Flight Procedures Cover Page	Task Action: FLIGHT CHECK	Task Type: IAP	Estimated Chart Date: 05/21/2020	APWS Task ID: 810C1DDCA50948FCA2D1D33EBA83708E	APWS Request ID: 40D87A0CA0814EDFBC7FA50249559421
Procedure: RNAV (GPS) RWY 13 AMDT 3		Enroute: NO	Specialist: Fowler, Shane		Agreement Number:
Airport ID: KPVU	Airport Name: PROVO MUNI		Airport City: PROVO		State: UT
Facility ID:	Facility Type:	Flight Inspection Remark Type: New FC Slot

## PROCEDURE REVIEW BOARD (PRB) RESULTS

### 5. Waiver/Approval: (PVU) PROVO MUNI, PROVO, UT - RNAV (GPS) RWY 13, AMDT 3

PRB Result: RECOMMEND RETURN FOR REWORK

RNAV (GPS) RWY 13

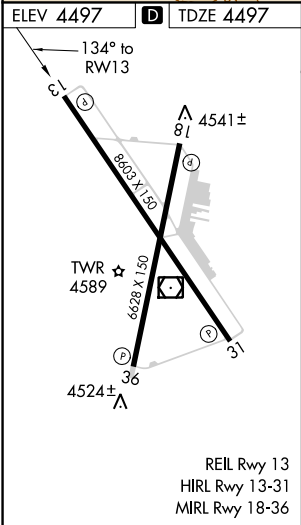
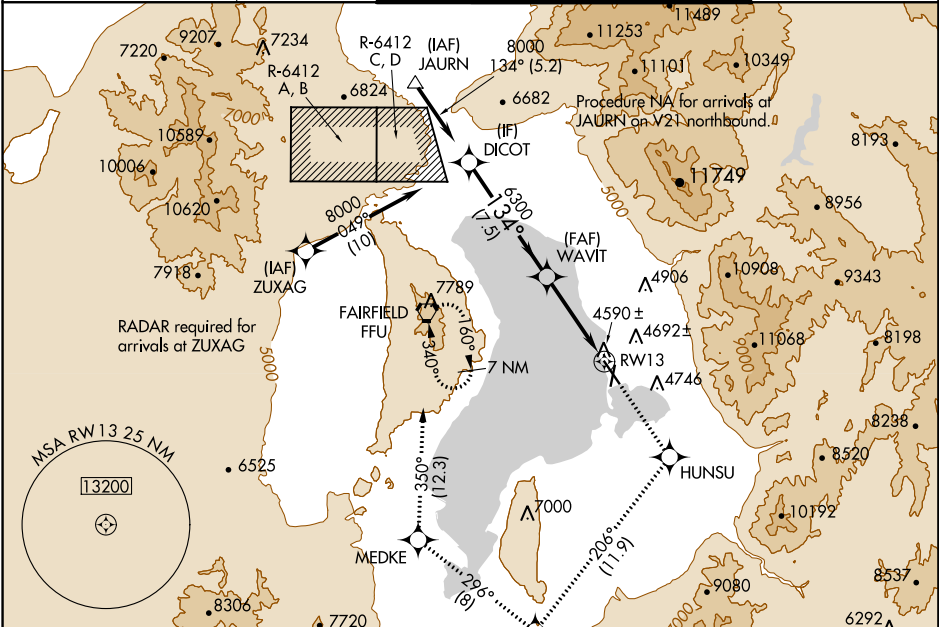
**T** Circling NA east of Rwy 18-36. Circling Rwy 18, 36 NA at night.  
**A** Rwy 13 helicopter visibility reduction below  $\frac{3}{4}$  SM NA. For uncompensated Baro-VNAV systems. LNAV/VNAV NA below -23°C or above 54°C.

**MISSED APPROACH:** Climb to 9000 direct HUNSU and on track 191° to FEBGO and on track 218° to ZARAK and on track 302° to JAMUK and on track 358° to FFU VORTAC and hold.
